SUBJECT: Final Case Closure with Continuing Obligations B&B Motors, 126 Old Highway 53, New Auburn, WI DNR BRRTS Activity #: 03-09-001350

Remaining Actions Needed B&B Motors, 126 Old Highway 53, New Auburn Wisconsin DNR BRRTS Activity # 03-09-001350

Re: Well abandonment forms for the former B&B Motors Site, 126 South Old Highway 53, New Auburn, Chippewa County, Wisconsin. AET Project No. 03-05719. WDNR BRRTS No. 03-09-001350. PECFA No. 54757-9999-26.

Figure B.2.b Residual Soil Contamination

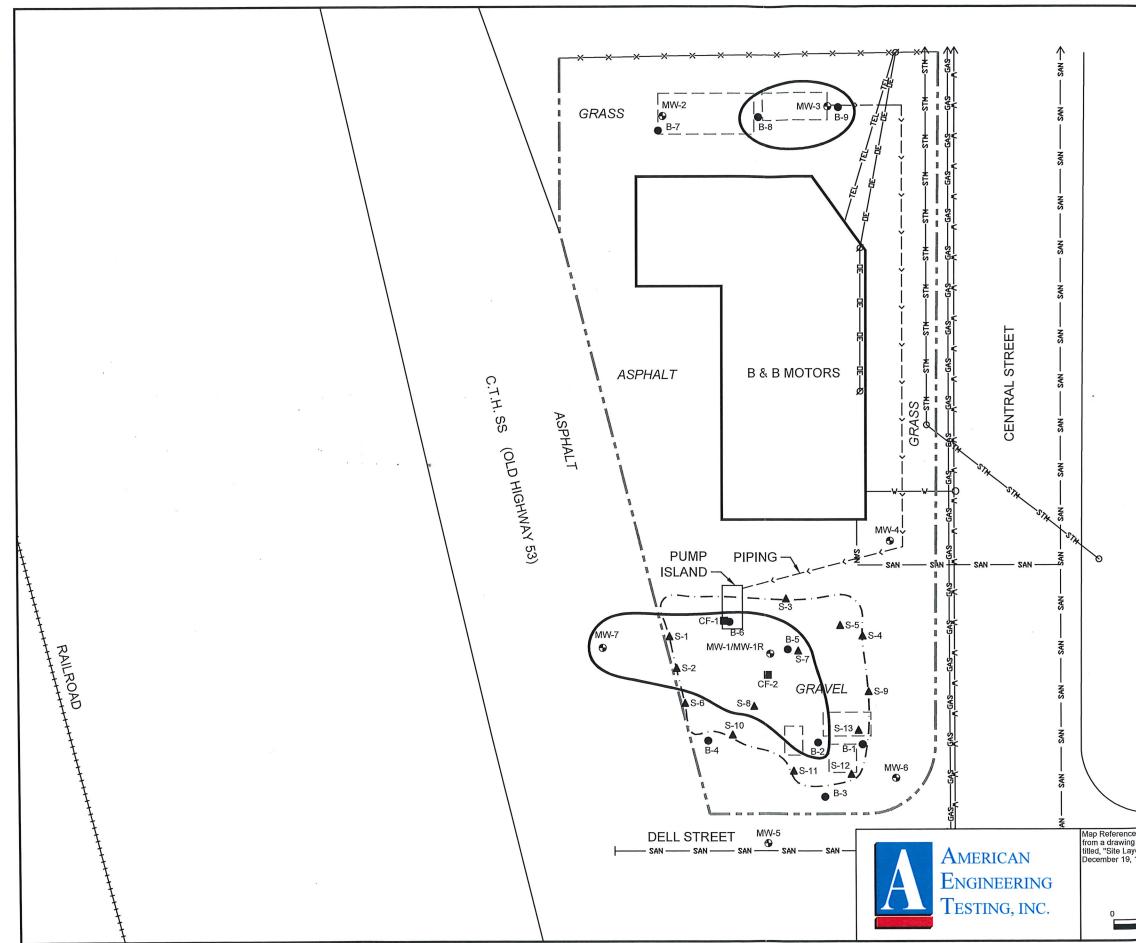
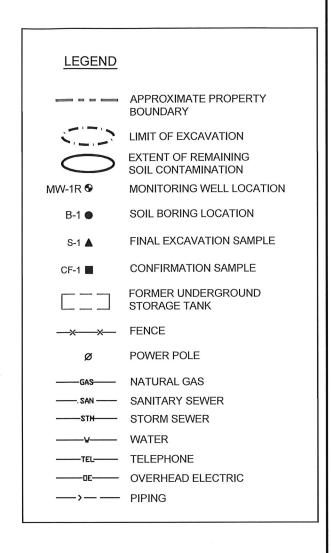
<u>Residual Soil Contamination</u> (ch. NR 718, chs. 500 to 536, Wis. Adm. Code or ch. 289, Wis. Stats.) Soil contamination remains at depth at soil sample locations S-1, S-2, S-8, S-7, CF-1, CF-2 and former monitoring well locations MW-7 and MW-18, as indicated on the attached map, Residual Soil Contamination, Figure B.2.b, dated May 1, 2017. If soil in the specific locations described above is excavated in the future, the property owner or ROW holder at the time of excavation must sample and analyze the excavated soil to determine if contamination remains. If sampling confirms that contamination is present, the property owner or ROW holder at the time of excavation will need to determine whether the material is considered solid or hazardous waste and ensure that any storage, treatment or disposal is in compliance with applicable standards and rules. Contaminated soil may be managed in accordance with ch. NR 718, Wis. Adm. Code, with prior DNR approval. This continuing obligation also applies to the ROW holders for 126 South Old 53 Street, New Auburn. In addition, all current and future owners and occupants of the property and ROW holders need to be aware that excavation of the contaminated soil may pose an inhalation or other direct contact hazard and as a result special precautions may need to be taken to prevent a direct contact health threat to humans.

al,	Figure B.3.b
	Groundwater Data - March 2017

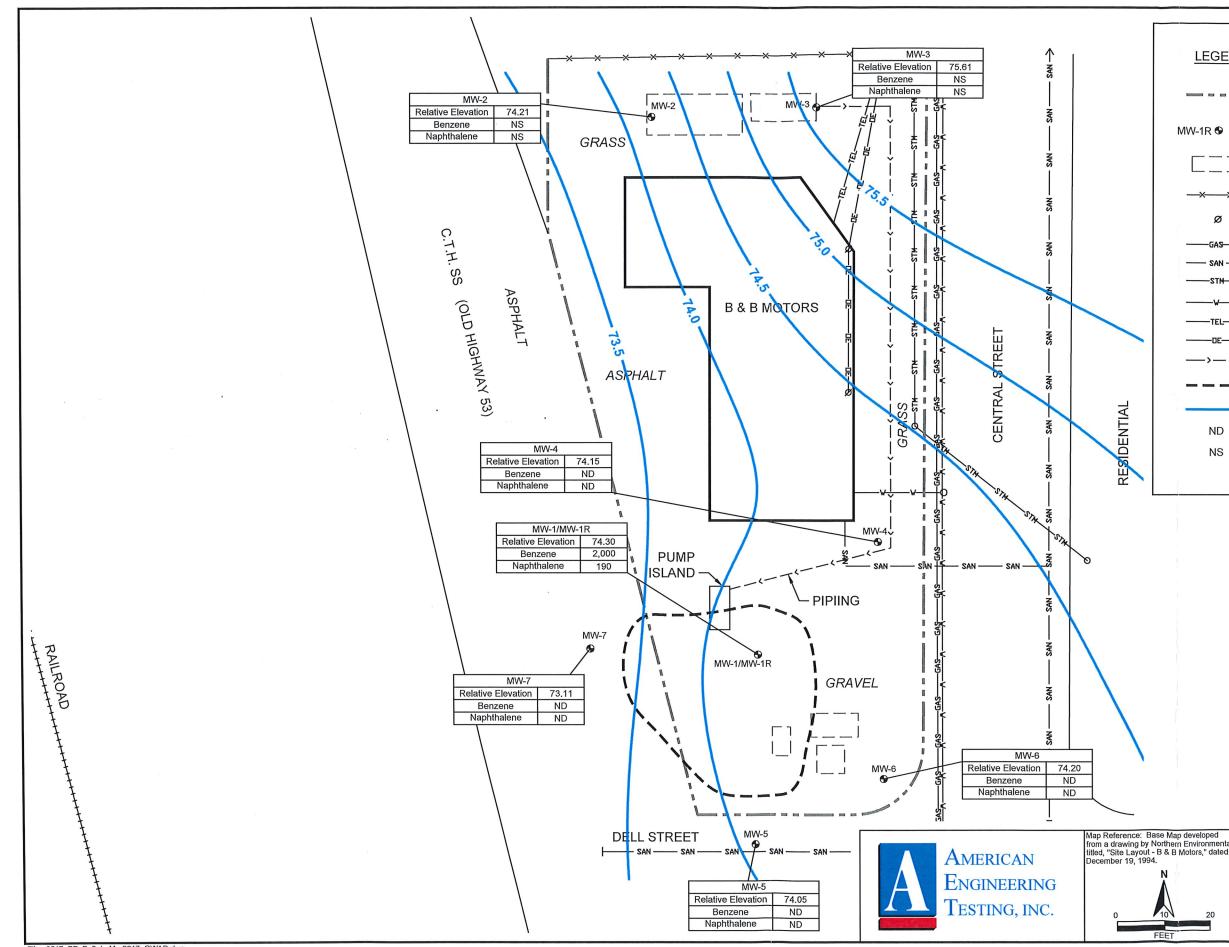
Groundwater contamination greater than enforcement standards is present both on this contaminated property and off this contaminated property, as shown on the attached map, Groundwater Data, Figure B.3.b, March 2017. If you intend to construct a new well, or reconstruct an existing well, you'll need prior DNR approval. Affected ROW holders were notified of the presence of groundwater contamination. This continuing obligation also applies to the ROW holders.

Map Reference: Base Map developed from a drawing by Northern Environmental titled, "Site Layout - B & B Motors," dated Figure B.2.b Residual Soil Contamination B & B Motors New Auburn, Wisconsin 20 FEET

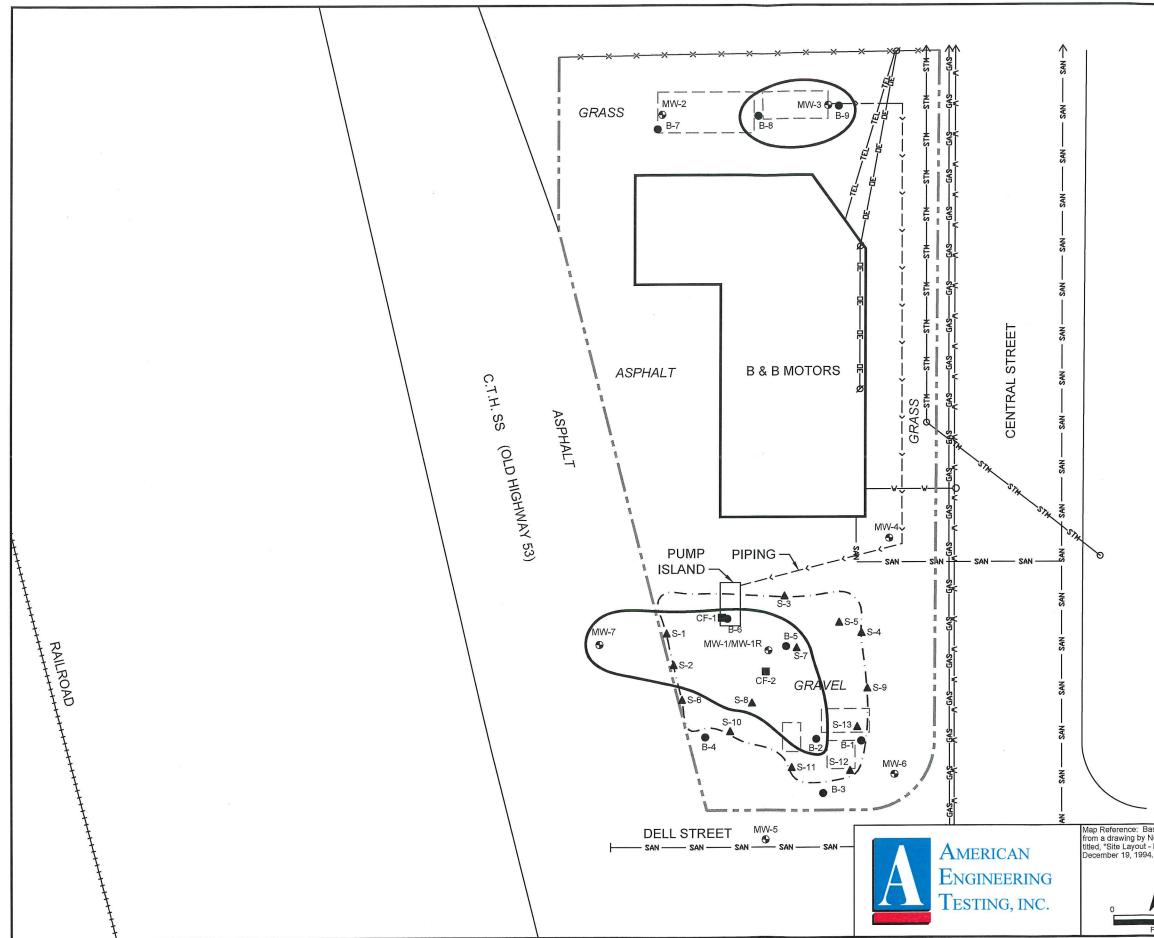
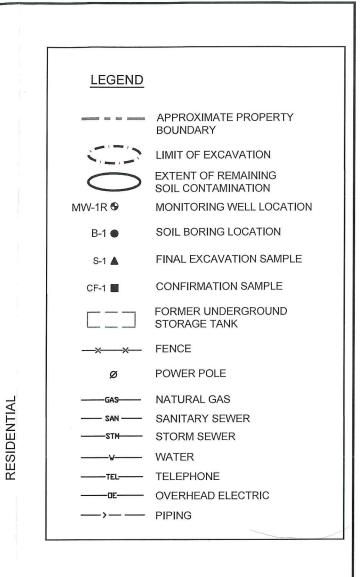
<u>Residual Soil Contamination</u> (ch. NR 718, chs. 500 to 536, Wis. Adm. Code or ch. 289, Wis. Stats.) Soil contamination remains at depth in the ROW at soil sample locations S-1, S-2 and former monitoring well location MW-7, as indicated on the attached map, Residual Soil Contamination, Figure B.2.b, dated May 1, 2017. If soil in the specific locations described above is excavated in the future, by you, as the ROW holder, the soil must be sampled and analyzed to determine if contamination remains. If sampling confirms that contamination is present, you, as ROW holder, at the time of excavation will need to determine whether the material is considered solid or hazardous waste and ensure that any storage, treatment or disposal is in compliance with applicable standards and rules. Contaminated soil may be managed in accordance with ch. NR 718, Wis. Adm. Code, with prior DNR approval. This continuing obligation also applies to the ROW holders for 126 South Old 53 Street, New Auburn.

Map Reference: Base Map developed from a drawing by Northern Environmental, Figure B.3.b Utiled, "Site Layout - B & B Motors," dated Groundwater Data - March 2017 N B & B Motors 0 20 FEET Date: 8/1/2017 AET Project No. 03-05719

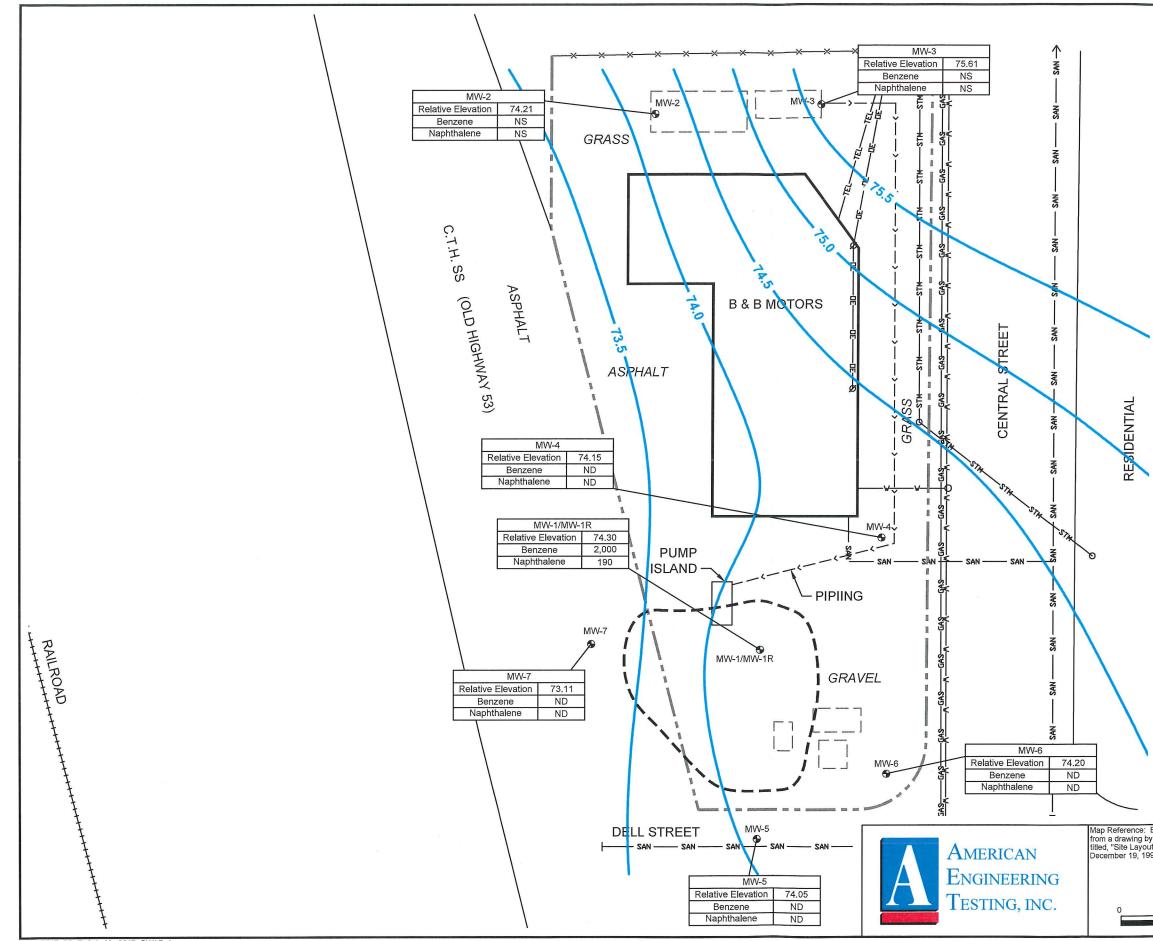
Groundwater contamination greater than enforcement standards is present both on this contaminated property and off this contaminated property, as shown on the attached map, Groundwater Data, Figure B.3.b, March 2017. If you intend to construct a new well, or reconstruct an existing well, you'll need prior DNR approval. As an affected ROW owner this continuing obligation is your responsibility.
